# UNITED STATES PATENT AND TRADEMARK OFFICE

10/574,656

<b>Office Action Summary</b>	<b>Application No.</b> 10/574,656	<b>Applicant(s)</b> LEE ET AL.	
	<b>Examiner</b> AZIM RAHIM	<b>Art Unit</b> 3744

## **DETAILED ACTION**

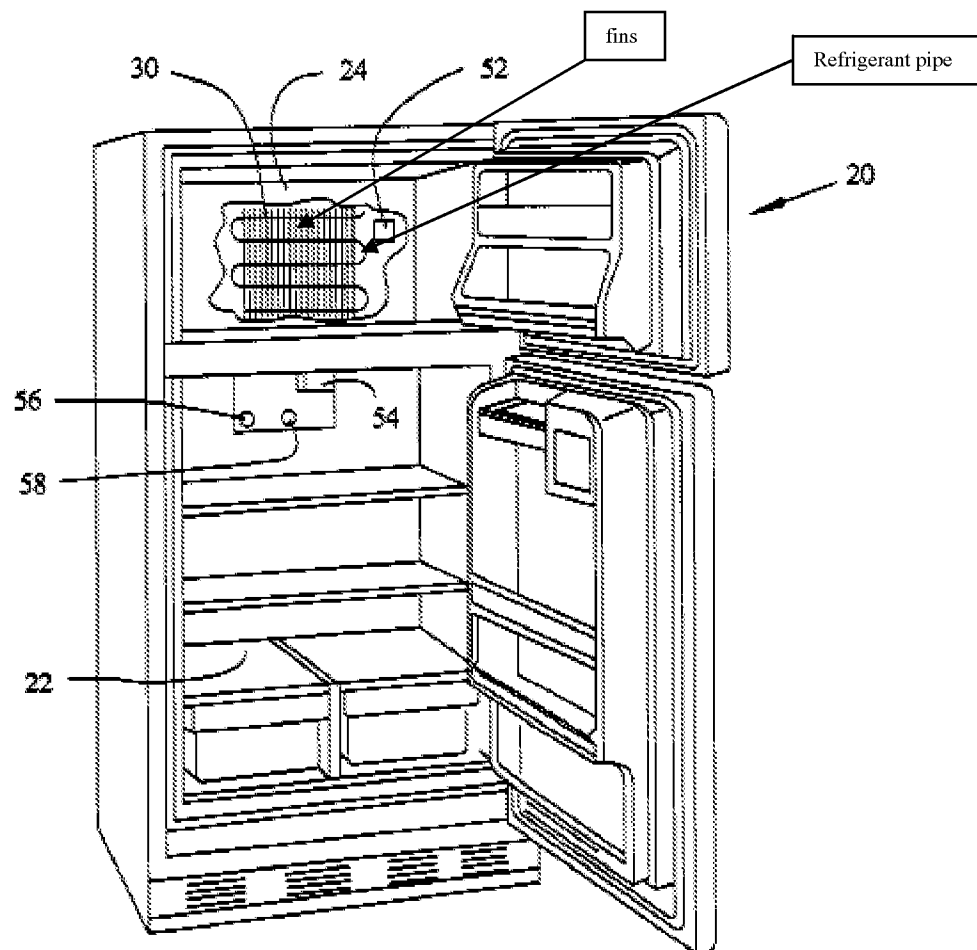
Regarding claims 1, 10-13 and 22, Schenk et al. disclose a refrigerator [figures 1 and 2] comprising: a cold air duct (46) for receiving cold air circulating inside of a refrigerating chamber (22) and a freezing chamber (24) [illustrated in figure 2]; a fan (40) in the cold air duct [illustrated in figure 2], for selective direction of the cold air in upward or downward [the fan is capable of performing the intended use of operation, which lends no structure to the claimed invention], a motor (42) for driving the fan downward [the motor is capable of performing the intended use of operation, which lends no structure to the claimed invention]; an evaporator (30) in the cold air duct [illustrated in figure 2] including; a refrigerant pipe [annotated in the figure below corresponding to conduit 32 in figure 2] having refrigerant flowing therethrough [column 4, lines 36-39], and fins [annotated in figure below] on an outside of the refrigerant pipe [illustrated below]; and open/close means (48) for closing a space, having the evaporator and the fan positioned therein, selectively [the open/close means is capable of performing the intended use of operation, which lends no structure to the claimed invention].

Schenk et al. fail to disclose at least one defrosting heater in the cold air duct in contact with the fins for selective emission of heat; wherein the defrosting heater includes; a hot wire for functioning as a resistance body connected to a power source for emission of heat, and a film of an electrical insulating material surrounding an outside of the hot wire.
